Proposal for draft amendments to Regulations No. 13-H relevant to the separate ESC/BAS regulation proposal

Annex 2, Approval mark and Paragraph of Model A, amend to read:

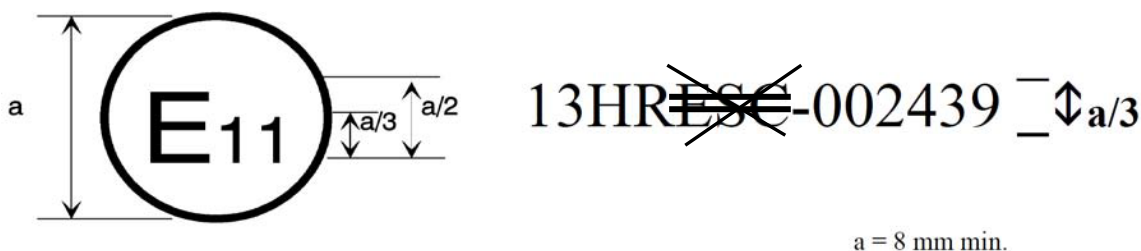
" The above approval mark affixed to a vehicle shows that the vehicle type concerned has, with regard to braking, been approved in the United Kingdom (E11) pursuant to Regulation No. 13-H under approval number 002439. The first two digits of the approval number indicate that the approval was granted in accordance with the requirements of Regulation No. 13-H in its original form. ~~The additional marking "ESC"~~

~~indicates that the vehicle meets the Electronic Stability Control and Brake Assist System requirements of Annex 9 to this Regulation. "~~

1. The definition of the words, the marking, the required performance, and the equipments relevant to ESC and/or BAS are not necessary.
2. The example of the approval mark should not contain any reference to ESC.
3. New paragraphs 12.XX: As from the time ESC/BAS are removed from the R13H regulation, the manufacturers won't have the possibility to request approval for ESC/BAS via UN R13H. Some transitional provisions may be necessary for ensuring a proper synchronization of the removal of ESC/BAS provisions from UN R13H with the entry into force of the new regulations on ESC and BAS. Yet OICA requests guidance from GRRF on this.
